October 5, 2022 (revised from original application 6.10.22)

Application for Zoning Amendment

Project: Prose Fircrest

REGARDING: Alliance Prose Zoning Amendments Case #22-04 Comments

EX 1: Regulating Plan (Current and Proposed)

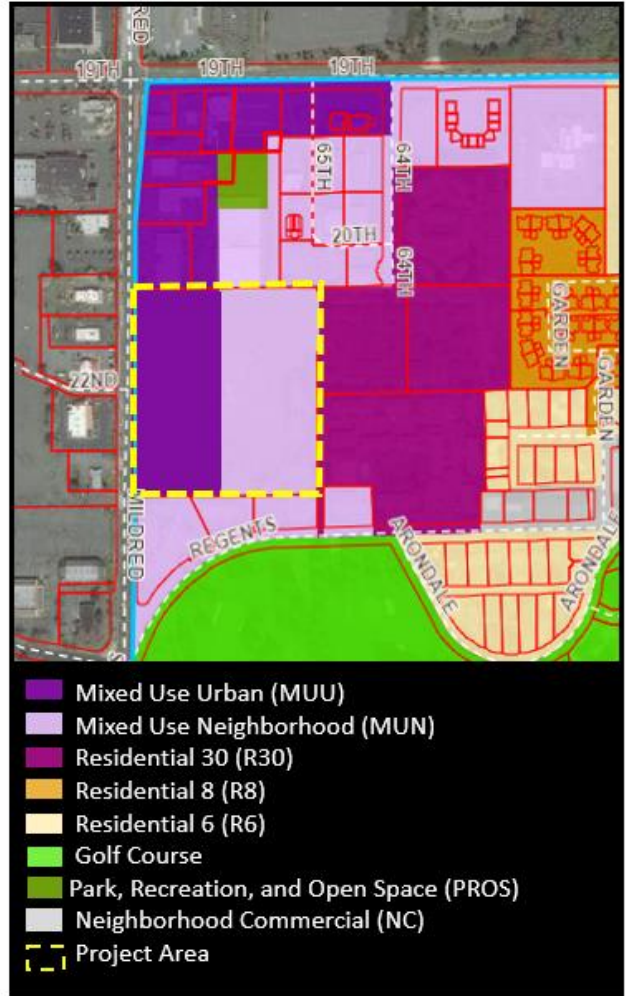
- 1.1) (07/28/2022) The proposed revisions to the zoning map are problematic in that the proposed boundaries are tied directly to a preliminary site plan that will likely change before it is approved. The proposed boundaries are unmanageable due to their complex configuration. The zoning map boundaries should be simplified before this application goes to the hearing examiner.

- 1.2) (07/28/2022) The City proposes eliminating the PROS zoned areas from the Alliance Prose site in their entirety. This would remove potential future constraints on open space locations within the project site if the final design were to require them to be reconfigured or relocated. City support for this approach would be predicated on additional amendments being made to the FBC text, per the comments in the following section.

- 1.3) (07/28/2022) Consistent with comment 2 above, the zoning map (and regulating plan map) would show the boundary between the MUN and MUU districts at the centerline of 66th Avenue. A description of the proposed boundaries should be provided.

- 2.3) (07/28/2022) The adopted FBC text in Section OS.1D requires a minimum of 5% of site area to be open space. The two PROS green spaces on the adopted regulating plan and the zoning map represent more than 10% of the project site. It is the City's expectation that if these two areas are relocated and reconfigured per the text amendment application, the area of each of these revised open spaces should be comparable to, or at least approach, the PROS areas shown on the adopted regulating plan.

G+A Response: Based on recommendations from the City, the Applicant is proposing to remove reference to Open space from the zoning map and alternatively define such requirements within the OS.1 and OS.2 portions of the FBC. This eliminates any confusion regarding the physical size, location, and configuration of the open space within the subject property.

G+A Response: G+A supports removal of PROS from map. See OS.2 for added language within the regulatory text amendment process application.

G+A Response: G+A proposes to maintain the location of the line between the MUN and MUU districts on the zoning map. This line is presumably located at the centerline of 66th as further

defined by the final specific location to be confirmed as part of project entitlements. The provision of a legal description articulating the location of the district boundaries shall be provided with the confirmation of the associated street centerline.

G+A Response: The Applicant is proposing to eliminate OS designations on the zoning map and the FBC regulating plan. Alternatively the applicant is defining the requirement for OS within the OS.1 and OS.2 FBC excerpts. In addition to clarifying the minimum size of the plaza requirements the Applicant has included the requirement to meet or exceed a 10% Open Space (OS) in lieu of the 5% currently identified. The Applicant has also proposed language to define the limits of open space that may be counted towards the Open Space requirement.
